## CALIFORNIA COASTAL COMMISSION

REGULAR CALENDAR  
STAFF REPORT AND PRELIMINARY RECOMMENDATION

Application No.: A-6-PEN-99-143

Description: Demolition of a one-story, 1,765 sq.ft. single-family home and detached garage and construction of a new one-story, 8,010 sq.ft. single family residence, a detached garage with guest quarters above totaling 800 sq.ft., installation of a 5-6 ft. high perimeter fence around the project site, widening of an existing paved access drive on the east from approximately 10 feet to 12 feet with four-foot wide shoulders and construction of an approximately 160-foot long, 12-foot wide access driveway for a neighboring lot to the north on a 1.3 acre hillside site consisting of two lots.

**EXHIBIT NO. 2**  
**APPLICATION NO.**  
**A-6-PEN-99-143**  
**Site Plan**

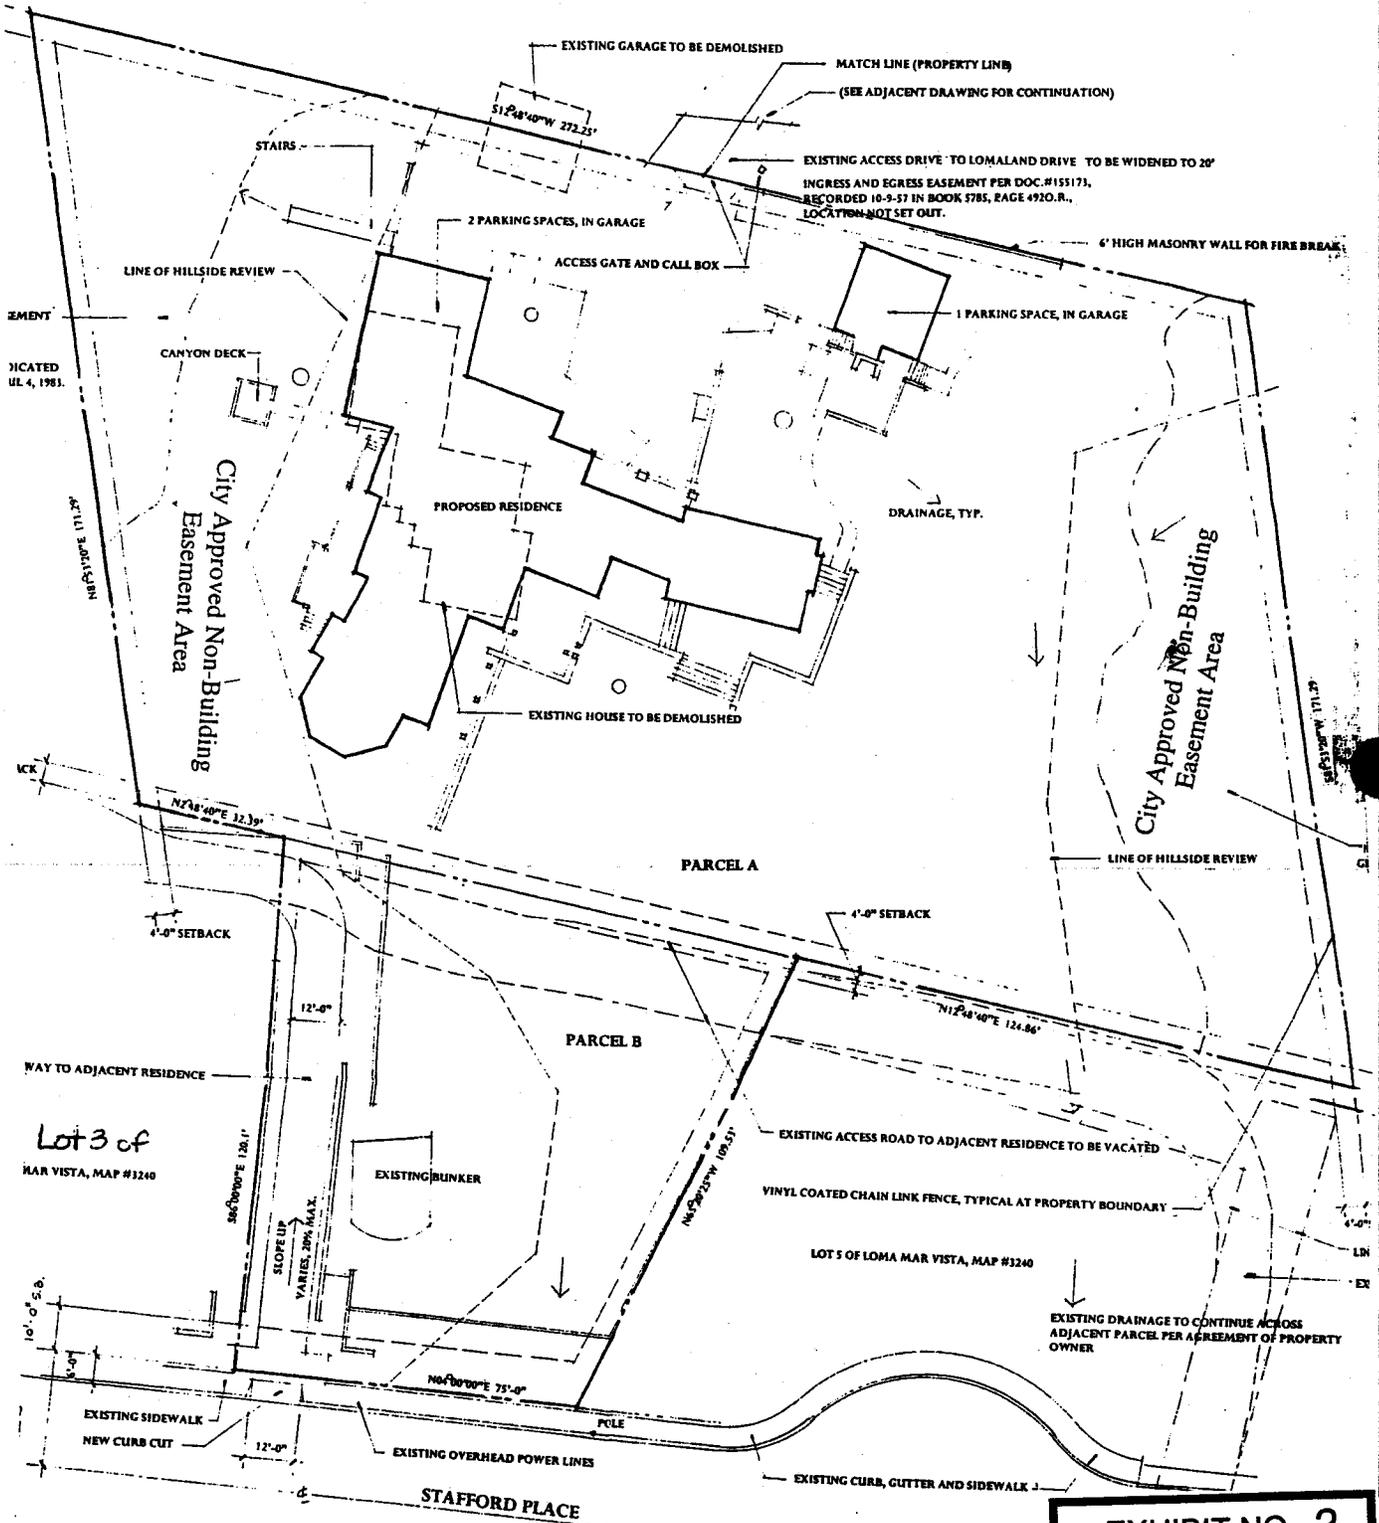
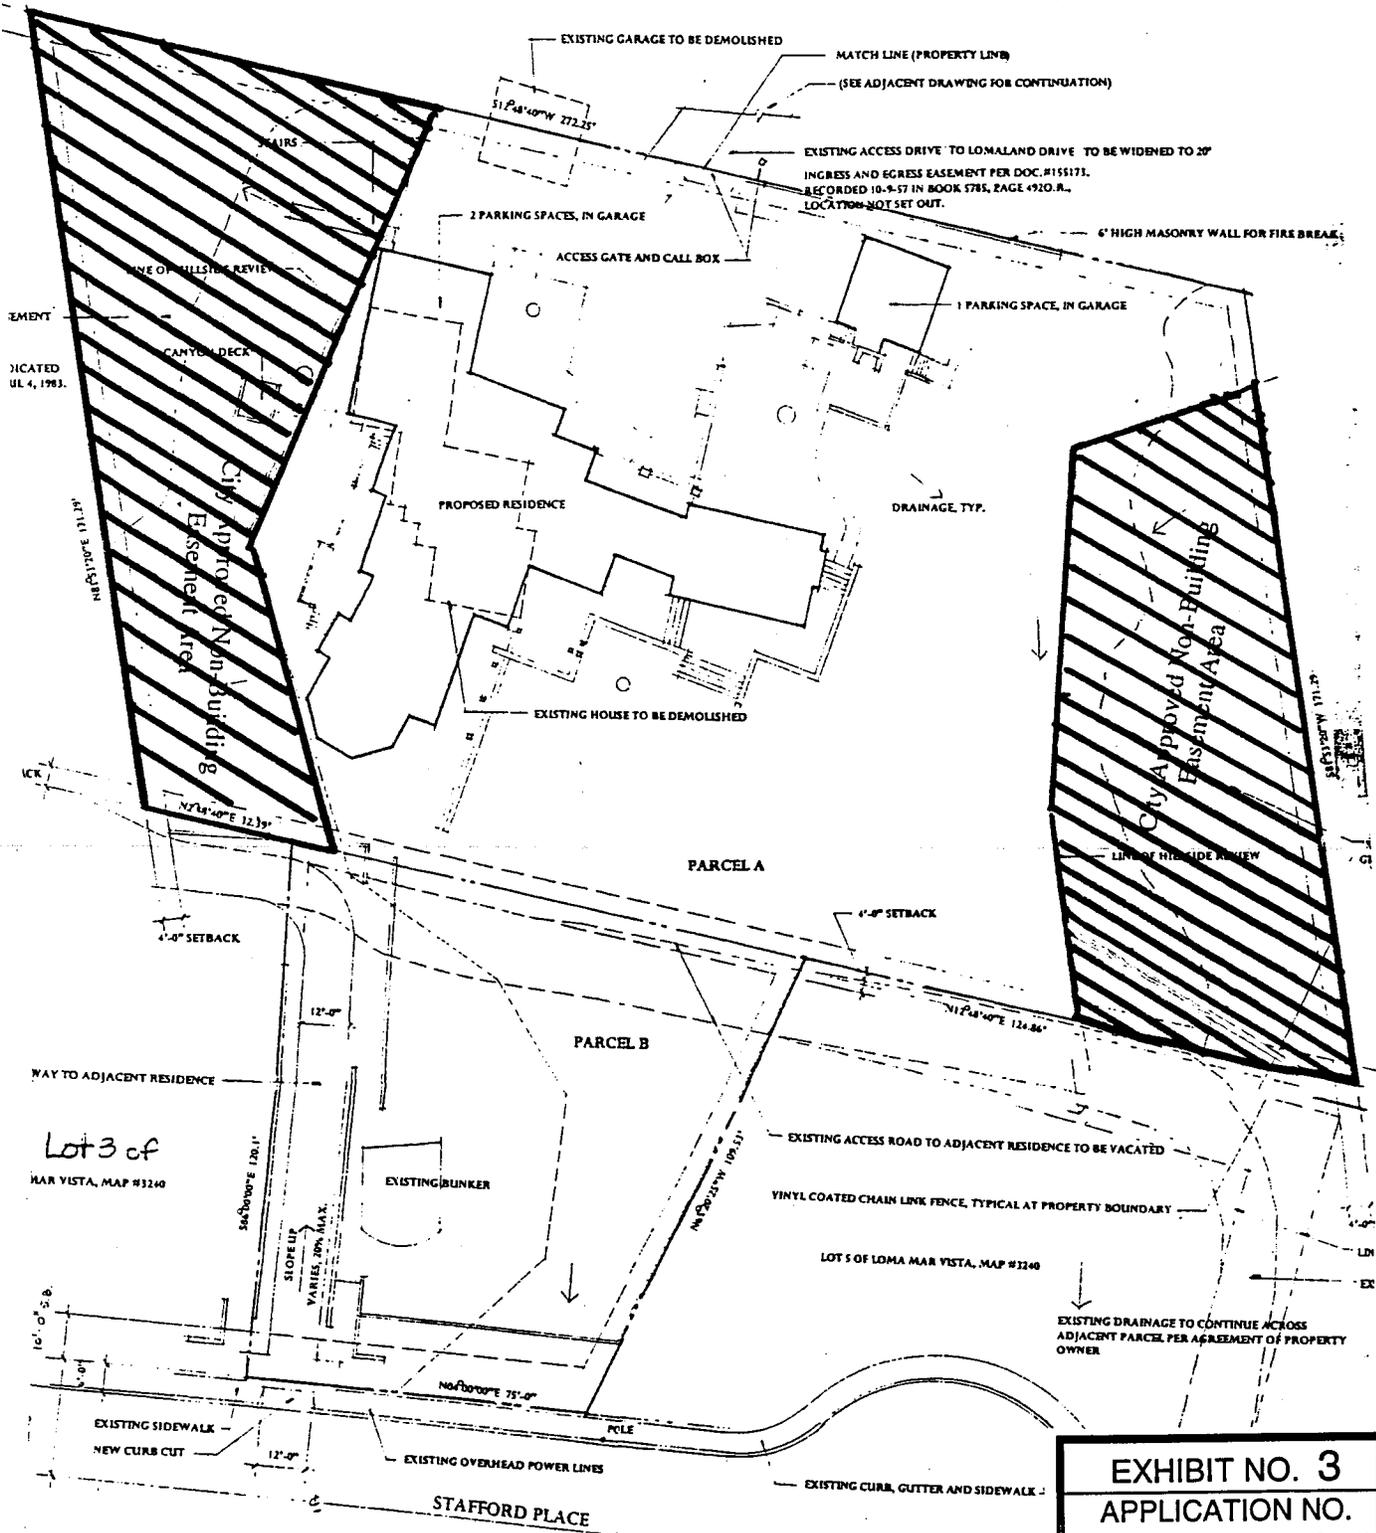
As shown on the project plans, there is a deck proposed which extends out onto steep slopes north of the proposed residence within the mapped Hillside Review (HR) Overlay zone. This deck appears inconsistent with the HR Overlay ordinance. However, the applicant has indicated that the deck will be cantilivered and does not involve any encroachment onto steep slopes for either its construction or its footings. However, it is not clear if brush management may be required for the deck that would extend into steep natively vegetated slopes. Because no encroachment for Zone 1 brush management is permitted within the steep slopes, if brush management is required, the deck will have to be entirely removed or relocated such that it does not result in the need to clear native vegetation for brush management purposes. Thus, Special Condition #1 requires that all structures shall be setback a minimum of thirty feet (30 ft.) from the area that is required to be maintained in open space pursuant to Special Condition #3 inclusive of both the primary residence and all accessory structures.

The deck is located entirely within the hillside review area, with footings embedded into a steep slope. How is that not encroachment? It would create a significant negative impact on the viewshed from the park. In addition, the plans show stairs placed on the same steep slope, east of the deck, which would further endanger this highly unstable hillside. In a letter<sup>10</sup> dated June 30, 1999 City staff directed the applicant to remove the stairs from the plan.

1. Final Revised Plans. PRIOR TO THE ISSUANCE OF THE COASTAL DEVELOPMENT PERMIT, the applicant shall submit to the Executive Director for review and written approval, final plans for the proposed development including a demolition plan, floor plan, site plan, foundation plan and elevation plan that have been approved by the City of San Diego. Said plans shall be in substantial conformance with the plans submitted with this application by Studio E Architects dated 9/14/99, except that they shall be revised to reflect the following:

The plans show that the deck does not encroach into steep slopes. The deck is elevated; it is not at grade and therefore requires no disturbance to the slope. The footings are to be located in an area of Zone 1 brush management, and no additional brush management is required for the deck.

Ro, Bentley's Old Driveway Measurements

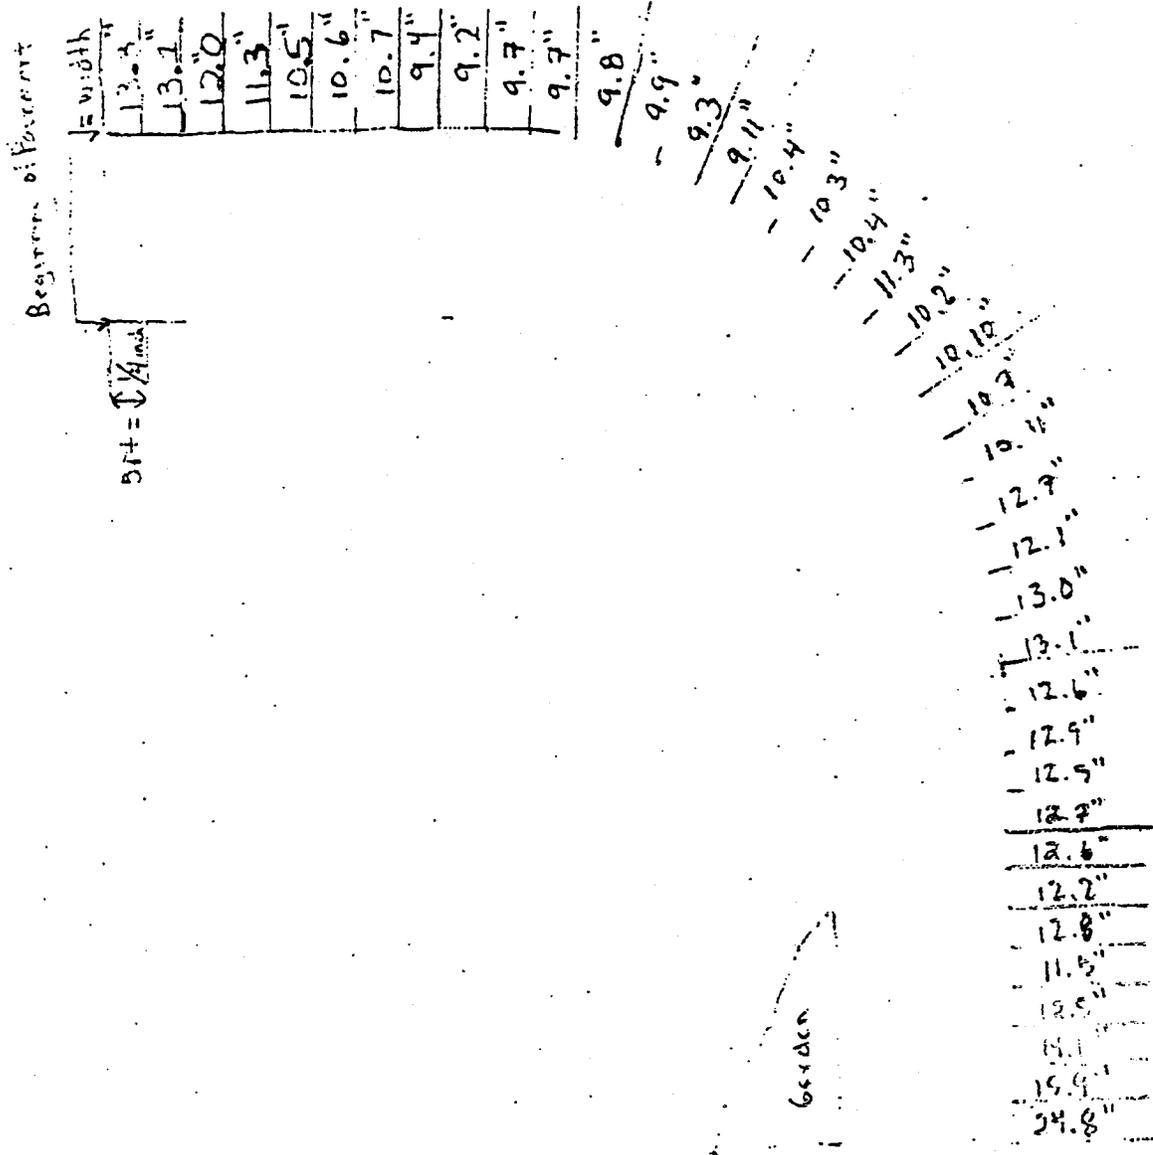
No grading will be required in order to widened the driveway to meet the City's requirement for a 10 foot driveway. Attached behind Tab 3 is a drawing which shows that the measurements of the existing driveway range in width from over 9 feet to over 24 feet. The majority of the driveway already exceeds 12 feet.
